29th April 2019
Head of Planning
fao Paul Moore
Dear Sir, Single storey side, rear extension
162 Starring Way,
Littleborough OL15 8RE
(ref 18/00872/HOUS John Van Eke)

I have been asked by the builder Wayne Patterson carrying out the work at the above to send in an adjusted drawing indicating the adjustments following comments by the neighbours:

Shed, rear extension
flat roof
pitched roof
side extension
STARRING WAY
shed
boundary fence
2.4m
2.4m
3m
162
154
173
12
2
BEAUMONT CLOSE
STUBLEY
The Barn
SITE
1:500

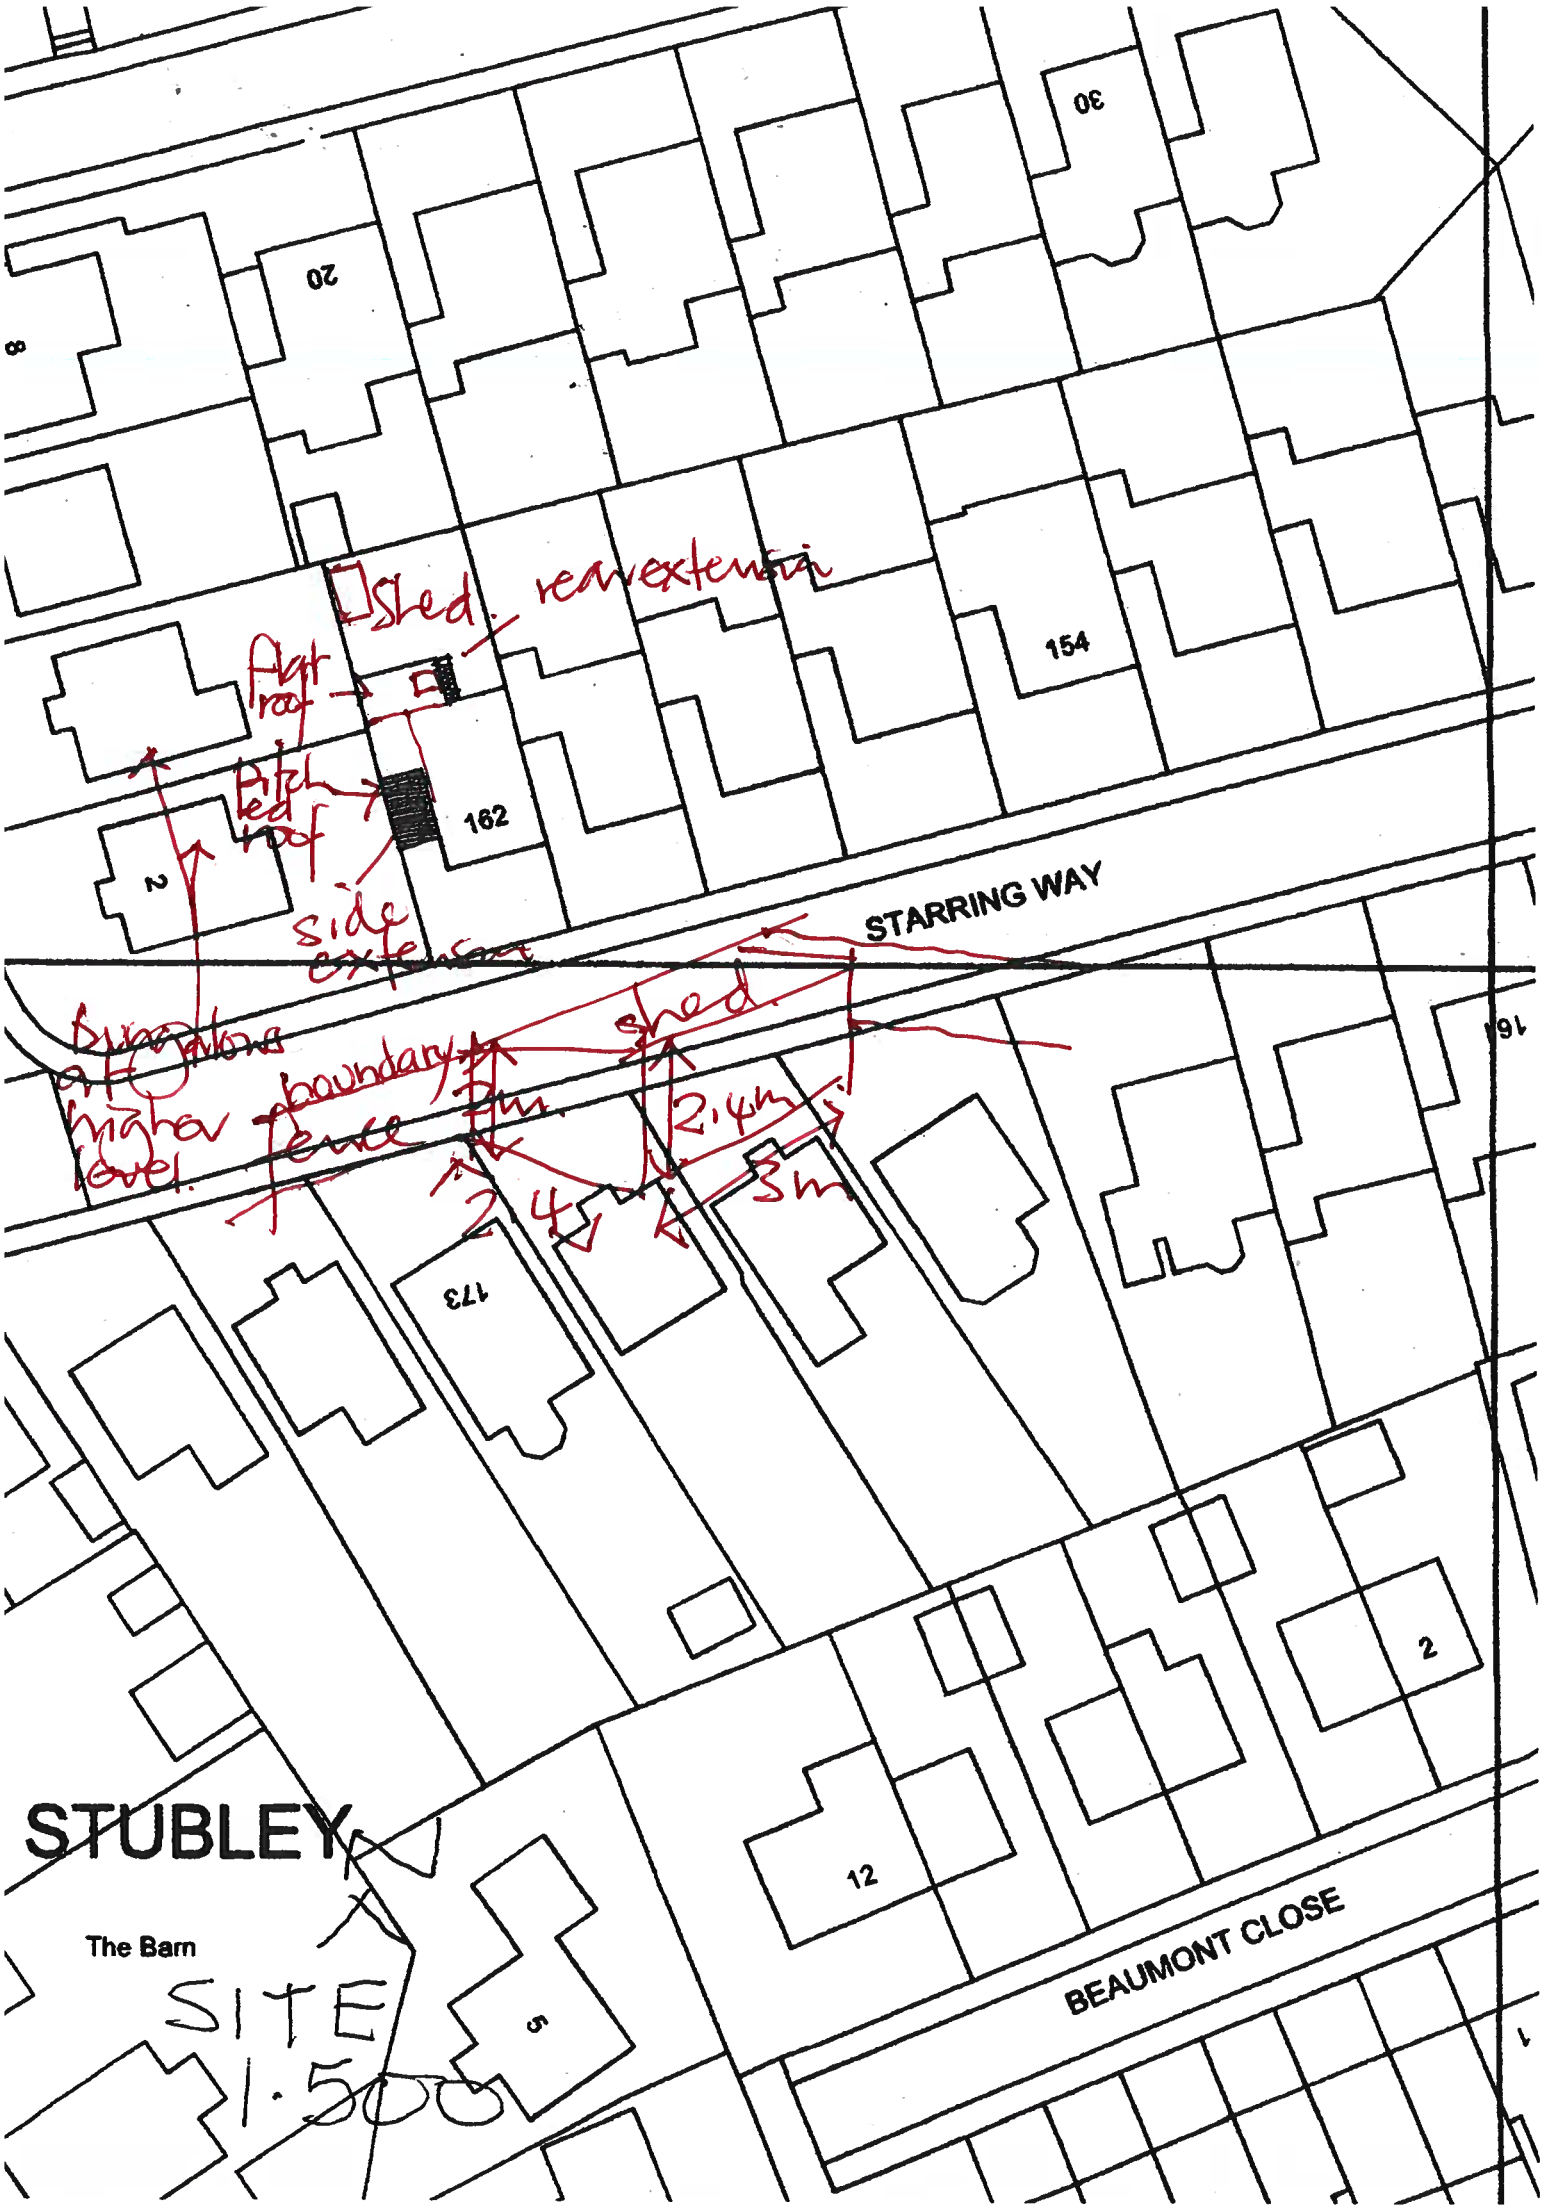
- The side extension has been set in line with the original garage wall with no oversale to the boundary.
- The new facing brick is a near match to the existing built over forty years ago.

- To the extended flat roof extension he has fitted a 1.5m lantern roof light rather than the 1m originally indicated.
- The applicant, Mrs Martin has erected a timber shed 3x2.4m to the rear garden to the boundary, 2m to the fence line with a monoroof to 2.4m to the garden.
